## Response to '[Comment on amt-2021-28](#)', Anonymous Referee #2

The paper describes the AMICA instrument which uses OA-ICOS to measure a variety of trace species in the atmosphere using two distinct axes. Details are given on the mechanical, electrical, and optical configuration of the instrument as well as preliminary laboratory calibrations and descriptions of flight campaigns the instrument has participated in.

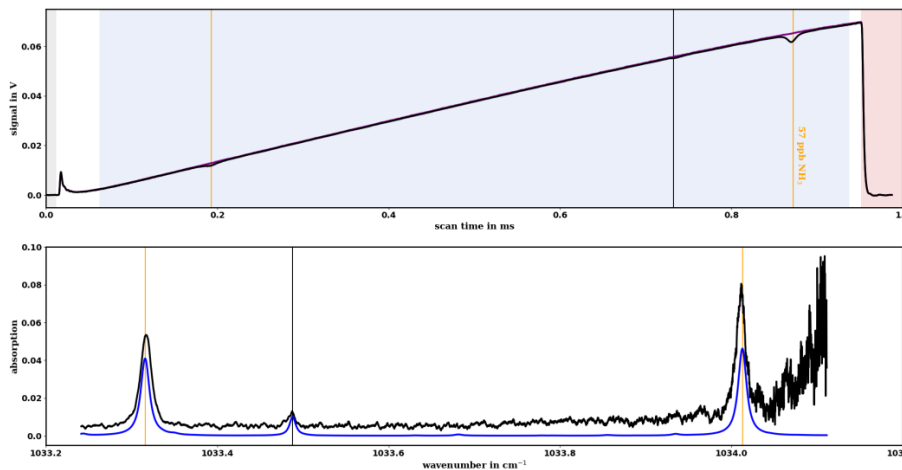
For the second axis, O<sub>3</sub>/NH<sub>3</sub>, only ozone has been measured. NH<sub>3</sub> has never been observed even in lab and therefore I think it should be removed from the list of molecules.

We prefer to leave the information that the  $\text{NH}_3$  line falls within the spectral range of the  $1030\text{ cm}^{-1}$  in the paper because the measurement of  $\text{NH}_3$  is a major target for future missions. For the SouthTRAC mission, we put our focus entirely on the realization of the  $\text{O}_3$  measurement, but it should be noted that the  $1030\text{ cm}^{-1}$  channel is using the same laser/mirror/detector configuration as the Ammonia Analyzer available from Los Gatos (<https://www.lgrinc.com/analyzers/overview.php?prodid=24&type=gas>) and the airborne Ammonia instrument described in the Leen et al. (2013) reference.

And in preliminary tests with the  $1035\text{ cm}^{-1}$  channel, we have recorded a  $\text{NH}_3$  spectrum with this channel in the laboratory:

As in Figure 10 in the paper, the upper panel shows the detector signal for one laser ramp, and the lower panel shows the spectrum in absorption space. The blue line does not show a fit but rather a HITRAN based spectrum for the 57 ppb  $\text{NH}_3$  mixing ratio in the standard that was used.

We chose not to include this spectrum in Figure 10 or otherwise show it in the paper because it was recorded while fine tuning the temperature and the ramp parameter setting of the laser prior to the SouthTRAC campaign, and the settings used are slightly different from what was used during campaign and the wavenumber scale for these settings is only approximate. Also, cavity pressure and temperature as well as some other housekeeping parameters had not been recorded to file at the time.
